AGENDA

MILWAUKIE PLANNING COMMISSION Tuesday, November 22, 2016, 6:30 PM

- 5.2 Summary: King Rd. Subdivision
Applicant/Owner: Mission Homes NW, LLC
Address: 5126 SE King Rd.
File: S-2016-001
Staff: Vera Kolas
 - 5.3 Summary: Harmony Road Mini Storage
Applicant/Owner: Han Thygeson
Address: 5945 & 5965 SE Harmony Rd.
File: CU-2016-001
Staff: Brett Kelter

SHEET
P300
JOB NO.
2312-022

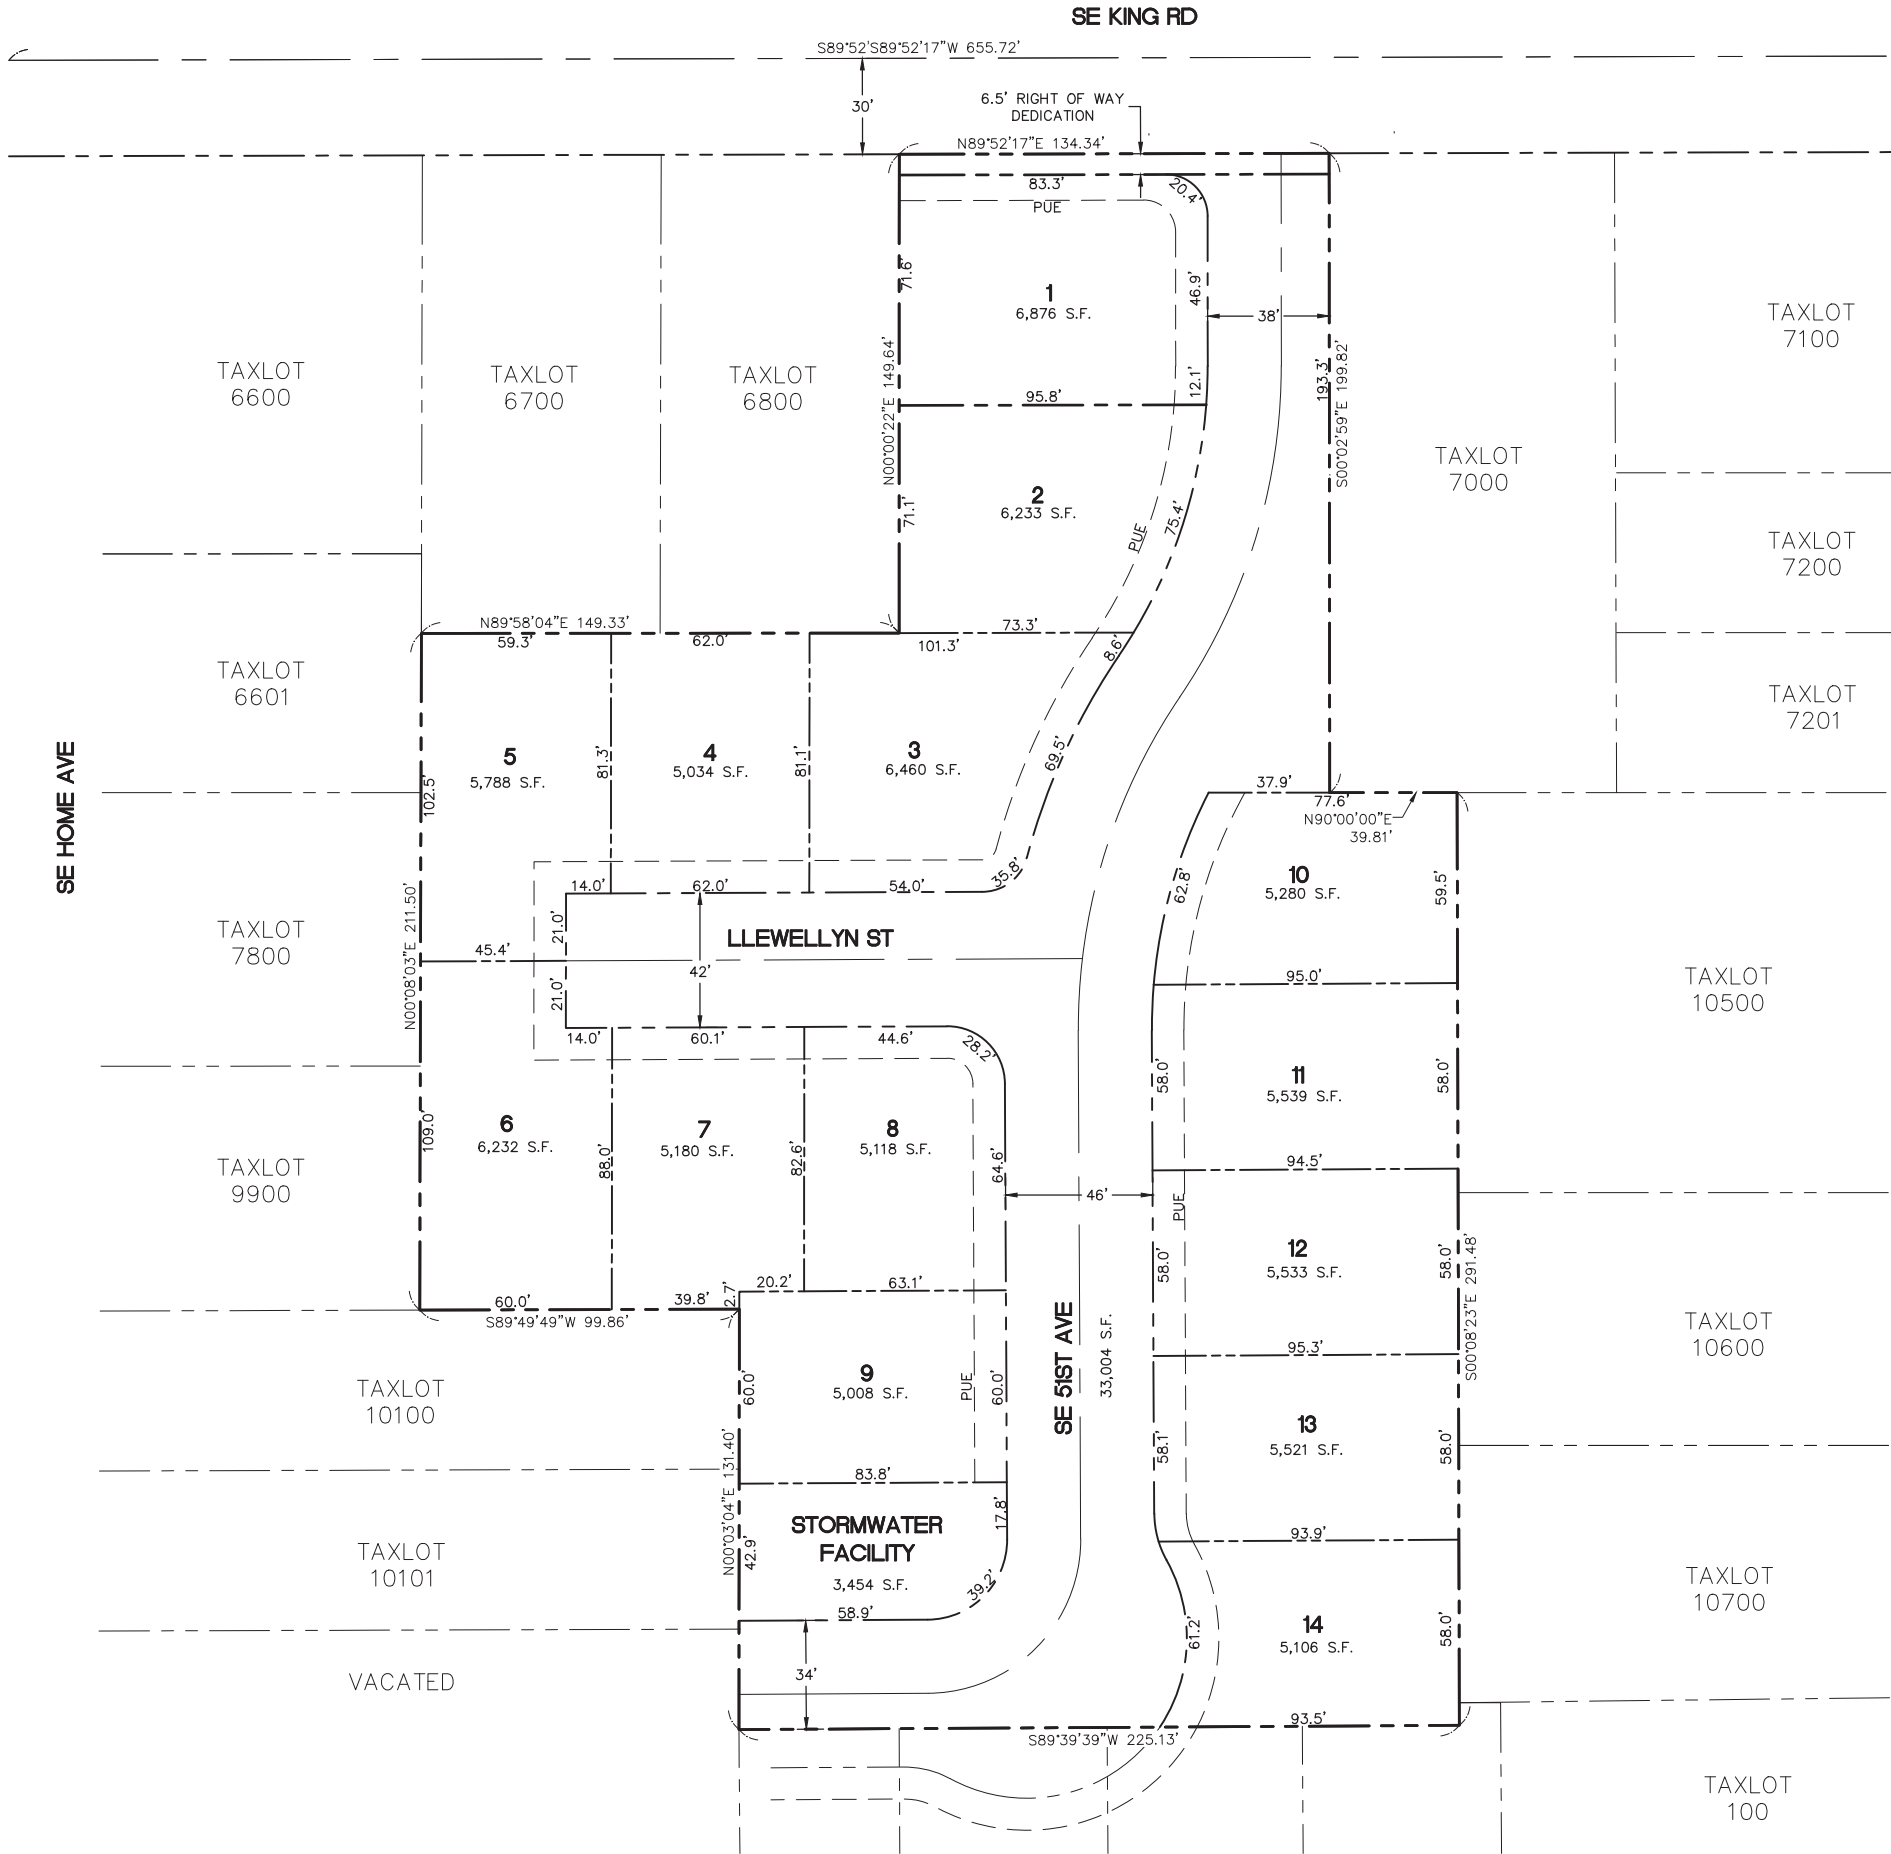
- b. *The preliminary plat as submitted (Sheet P300) has not been stamped by an Oregon registered land surveyor as required.*

- c. *The preliminary plat as submitted (Sheet P300) does not include the location by section, township, and range and does not include a legal description as required. The property description noted on Sheet P100 identifies only tax map and lot information with 2 lots listed, whereas 6 lots are the extent of the property.*

- e. *The preliminary plat as submitted (Sheet P300) identifies Tract A (1,272 SF): what is the purpose of Tract A? Information regarding its use, ownership, etc. does not appear to be included.*

Response: Sheet P300 of the preliminary engineering plan set has been stamped by an Oregon registered land surveyor.

Response: Sheet P300 of the preliminary engineering plan set has been revised to include the subject property location by section, township, and range, as well as a legal description. Sheet P100 has been revised to reflect the appropriate property description.

Response: Sheet P300 of the preliminary engineering plan set has been revised to reflect a public right-of-way dedication of 1,272 S. F. previously labeled Tract A.

SHEET
P400
JOB NO.
2312-022

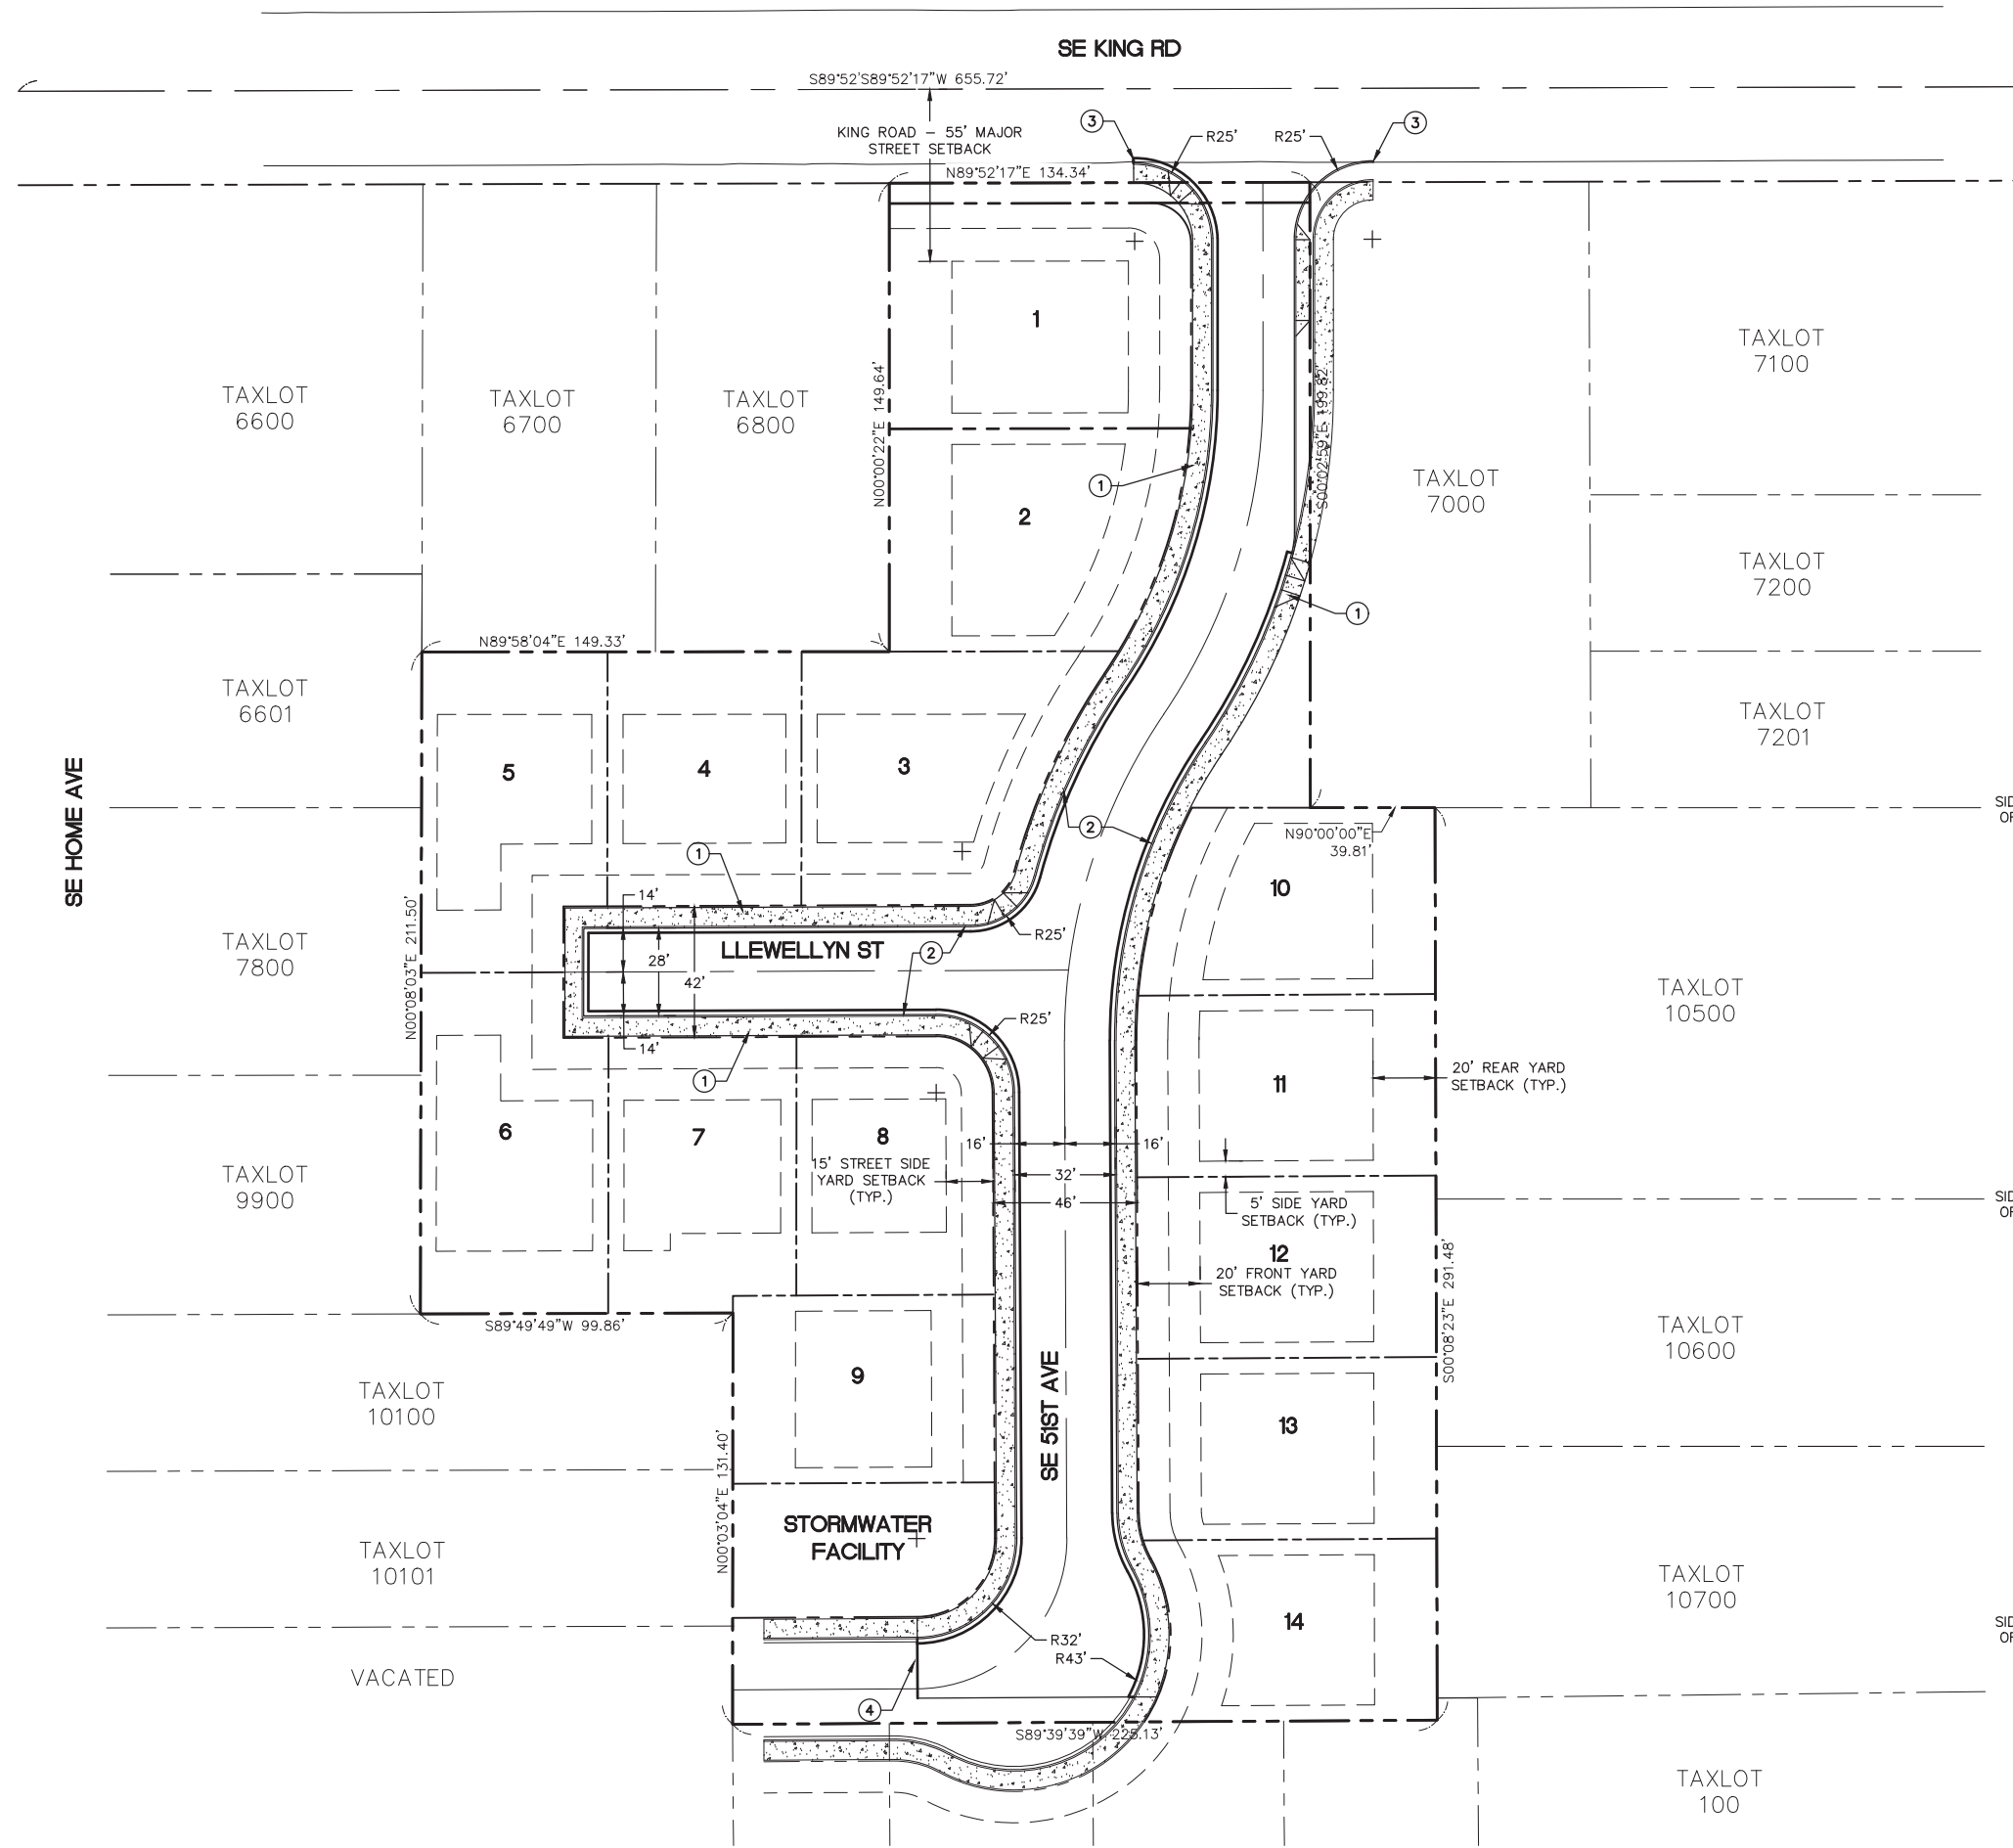
1. Street connection to King Road, this should be designed to present standards with full sidewalks and right of way. Not to existing sidewalks as noted in the document drawing P400 #3.

5. Management of storm water facility P400 (bottom of drawing #4):
 - a. Will the proposed area be the amount needed for the fire turnaround?
 - b. Will the street be complete or just an open area that needs maintaining?

- Sidewalk and paving will be constructed to the west property line. The line marked "4" on Sheet P400 of the preliminary plat is going to be the location of barricades indicating end of roadway. The south property line will be left open.
- As with any single family construction, there is no requirement for the builder to construct fencing. The erosion control plan submitted during the development process will require a silt fence at all boundaries of the project site.
